DRAWING AMENDMENTS

REMARKS

FIG. 1
(PRIOR ART)

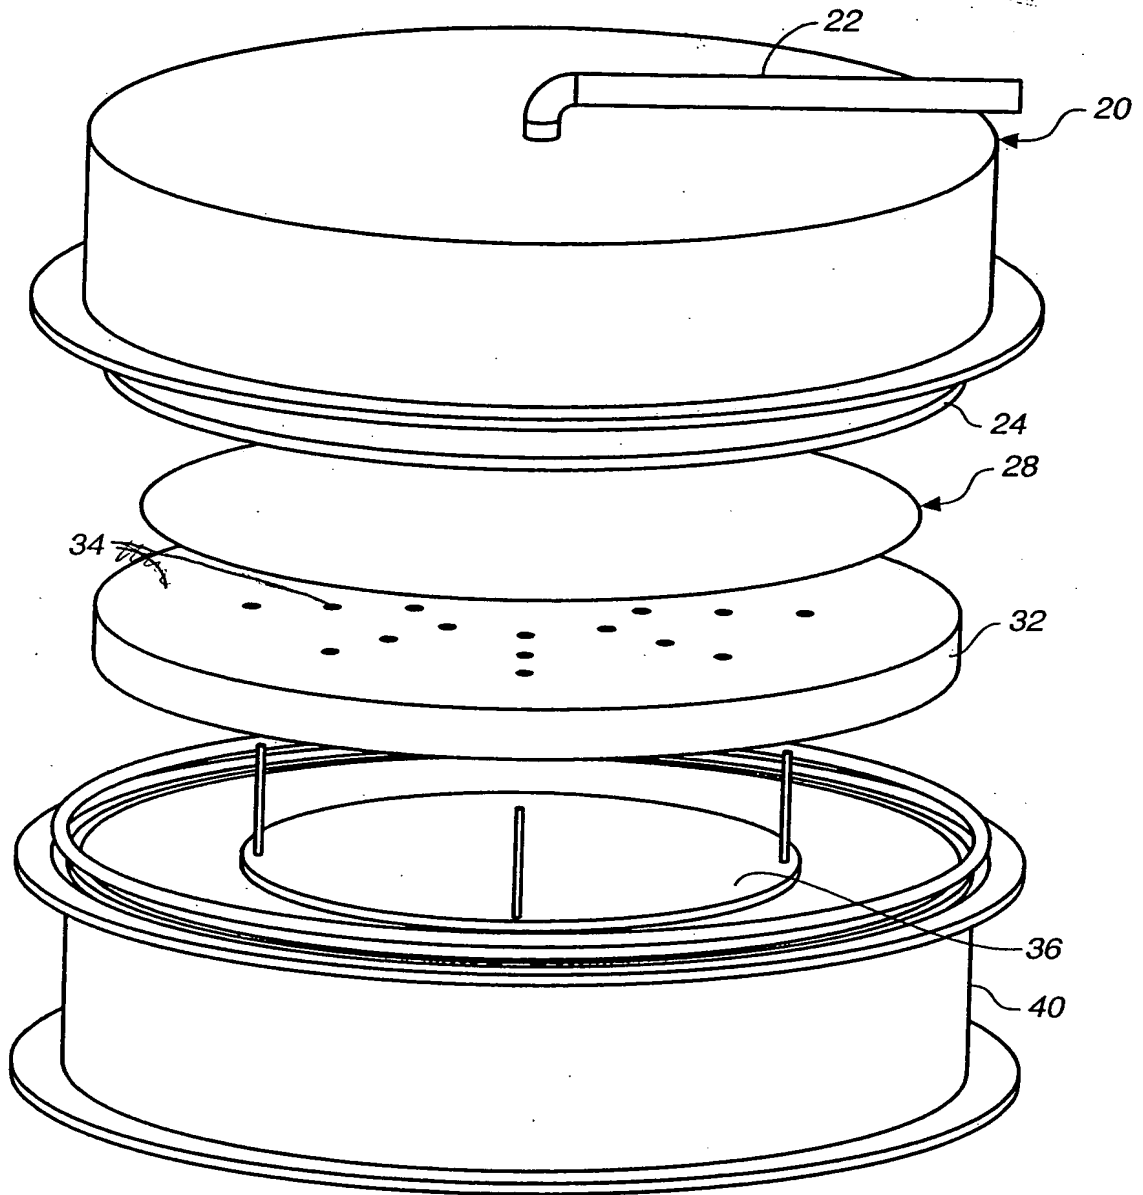
(2) The drawings were also objected to because reference numbers 132 and 133 of Figure 4 referred to the same part. An amended drawing is submitted showing reference number 133 referring to proximity pins 133 as shown in Figures 6 and 8. In addition, Figure 1 is amended so that proximity pins 34 are identified as shown in Figure 2.
